**Request for Additional Information No. 83 Supplement 1
(1230,1132,1233,1234,976), Revision 0**

U. S. EPR Standard Design Certification

SRP Section: 10.04.09 - Auxiliary Feedwater System (PWR)

Question 10.04.09-1:

Figure 2.2.4-1—Emergency Feedwater System Functional Arrangement
Sheet 1 of 4

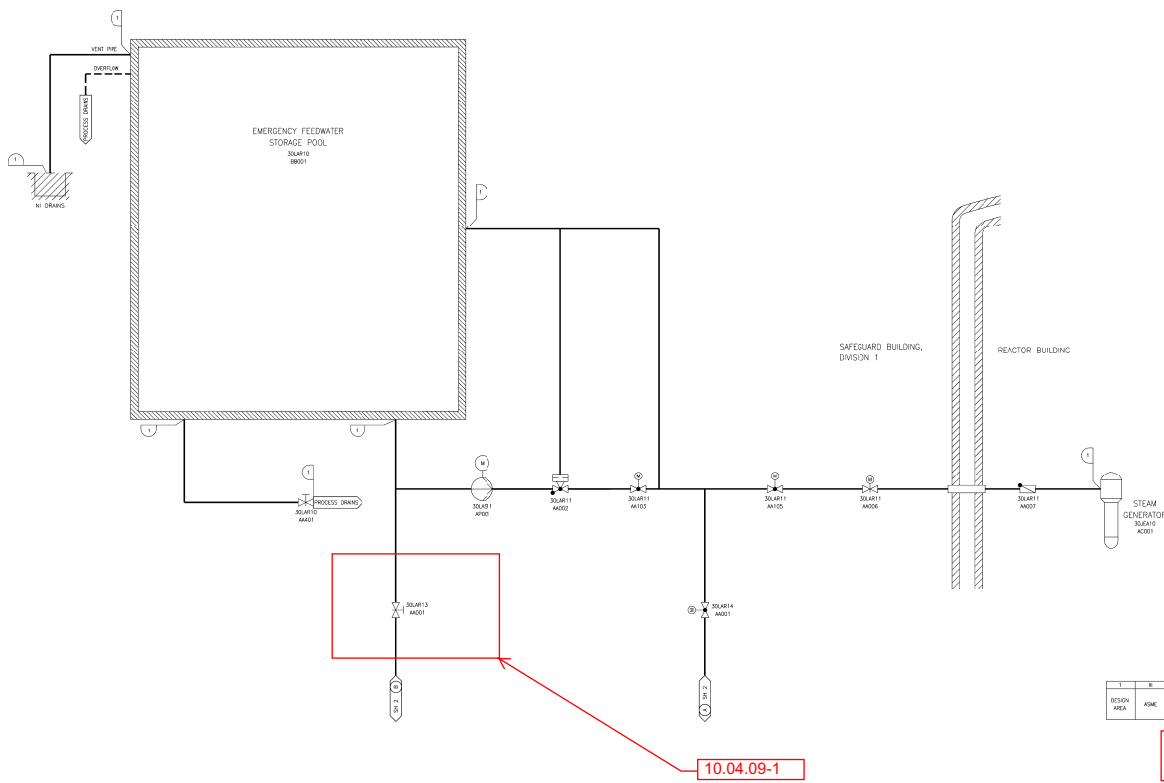
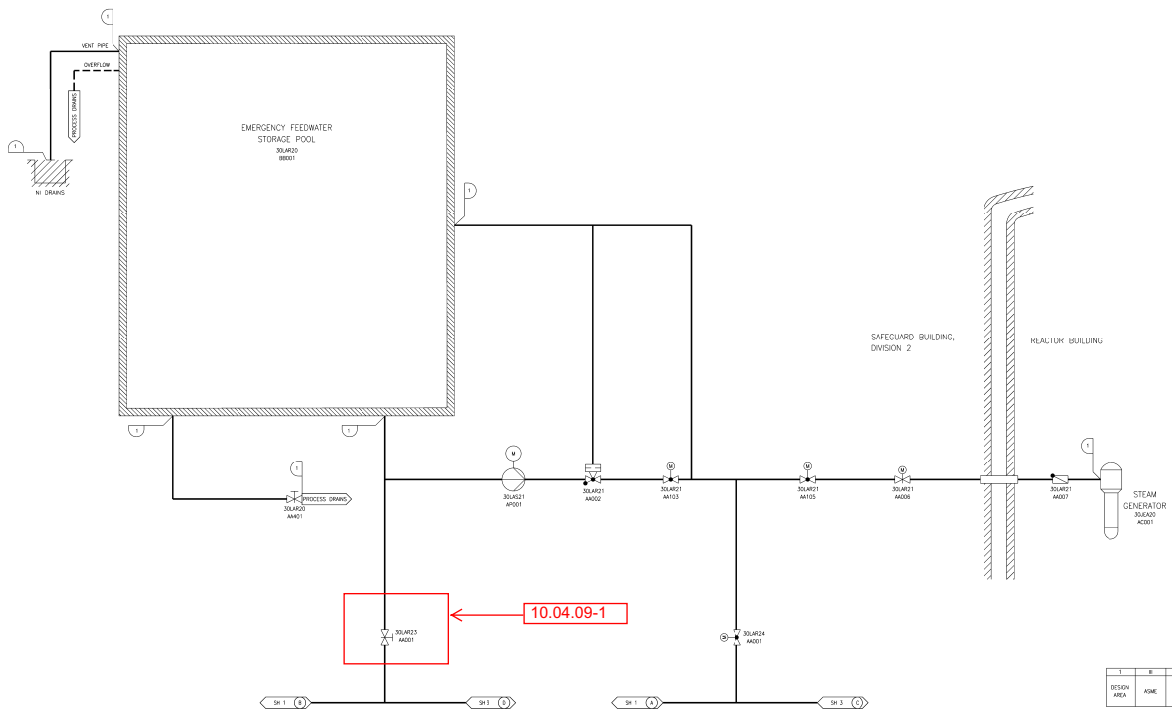
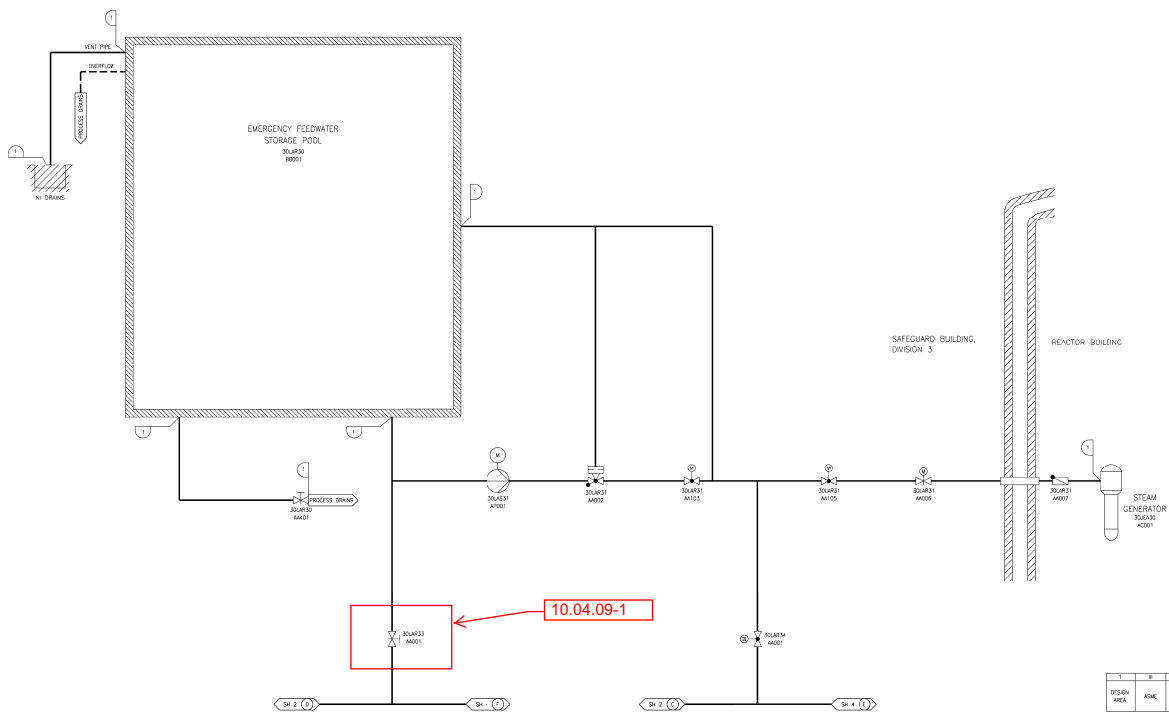
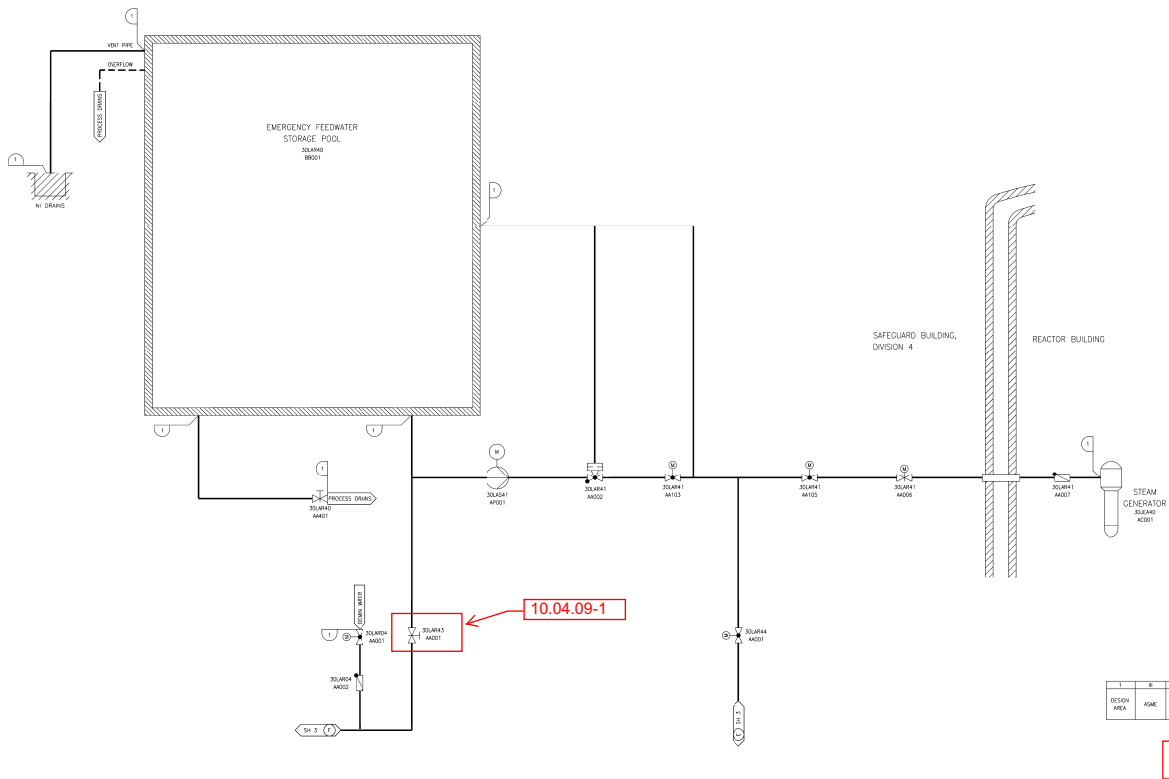
1. Explain in the FSAR how there can be physical separation between divisions of EFWS if storage pools all connected by normally-open valves.
2. Discuss in the FSAR whether the valves are safety related and/or powered by class 1E sources and explain why the header isolation valves are not included in Tier 1, Table 2.2.4.1.
3. Explain in the FSAR the absence of pool or suction piping leaks in the failure modes and effects table for the EFWS.
4. Provide in the FSAR the methodology by which the system design, with the pool header isolation valve normally open, precludes the possibility of an internal hazard resulting from a EFWS pipe break in one of the EFWS supply lines adversely affecting the other trains.

2. The supply header isolation valves are safety-related manual valves that may have to be opened to fulfill their safety function. U.S. EPR FSAR Tier 1, Figure 2.2.4-1, Sheets 1 through 4—Emergency Feedwater System Functional Arrangement will be revised to show the supply header isolation valves. U.S. EPR FSAR Tier 1, Table 2.2.4-1—EFWS Equipment Mechanical Design will be revised to list these valves.
